Errata and Added Information to
**MC68360 Quad Integrated Communication
Controller User's Manual Rev 1**

January 8, 1998

This document describes the latest information and changes to the first revision of the MC68360 user's manual.

Figure 6-6A External Components for 4.192MHz

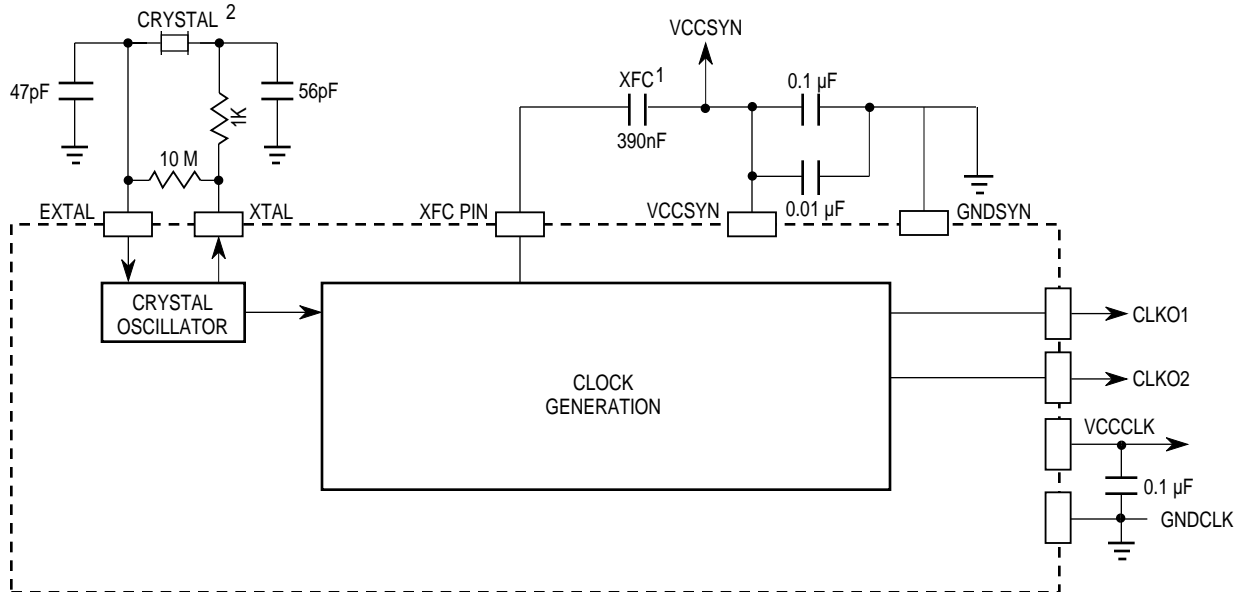
Also on page 6-14 the following figure should be added.

1. Must be low-leakage capacitor. See Section 10 Electrical Characteristics for recommended values.
2. Values are for 4.194MHz crystal and may vary due to capacitance on PCB.

Figure 10-44(a). MC68040/EC040 SRAM Read Cycles (TSS40=0, CSNT40=1)

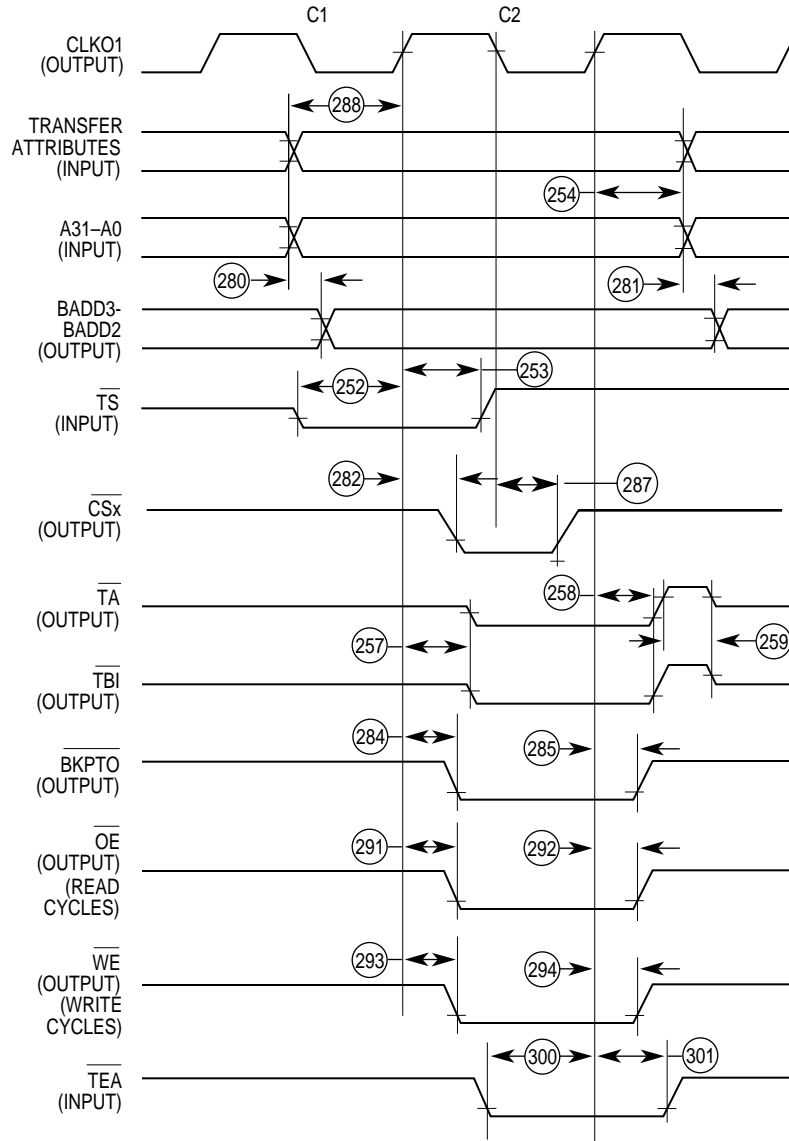
On page 10-57 the figure title should be replaced with the following

Figure 10-45(a) MC68040/MC68EC040 SRAM Write cycle (TSS40=1, CSNT40=1)

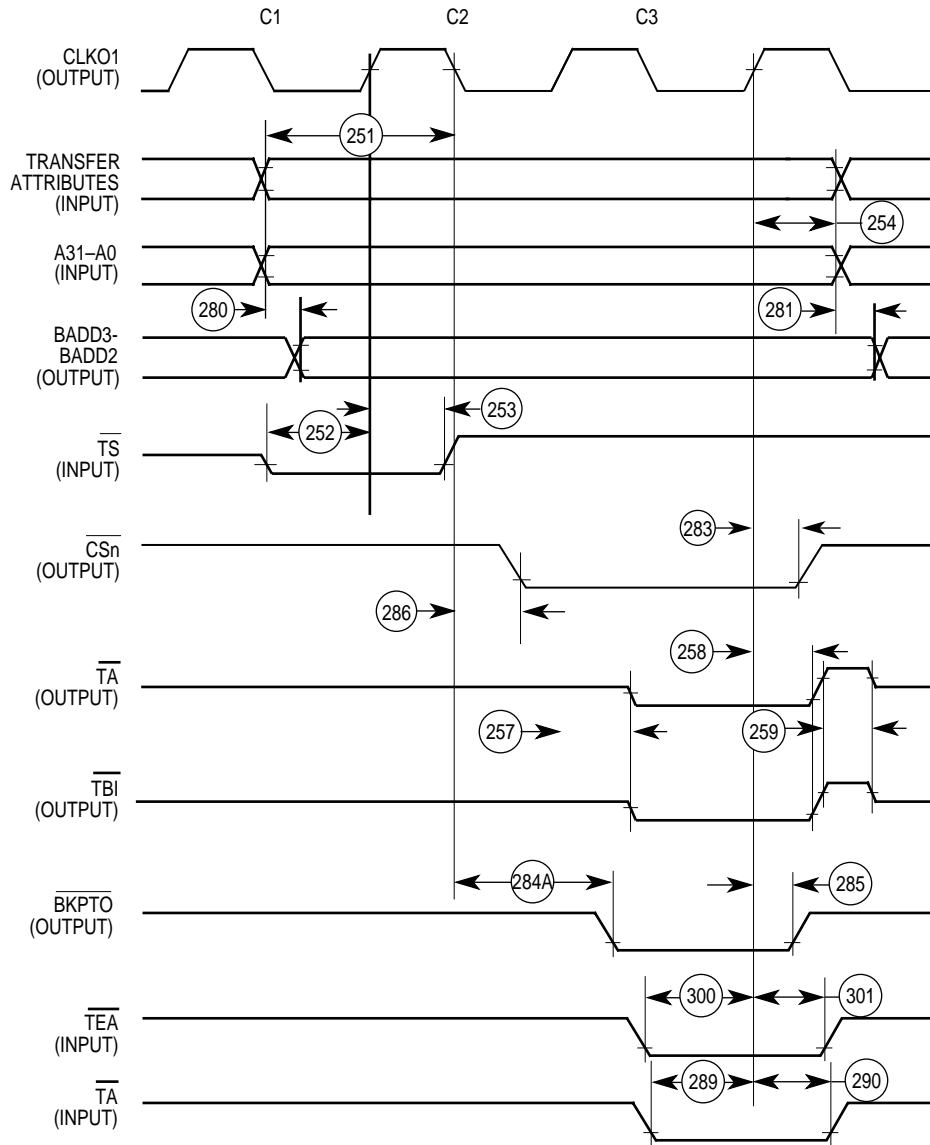
On page 10-58 the figure title for FIGURE 10-45 should be replaced with the following.

\overline{OE} and \overline{WE} signals are not supported when TSS40 is set to 1.
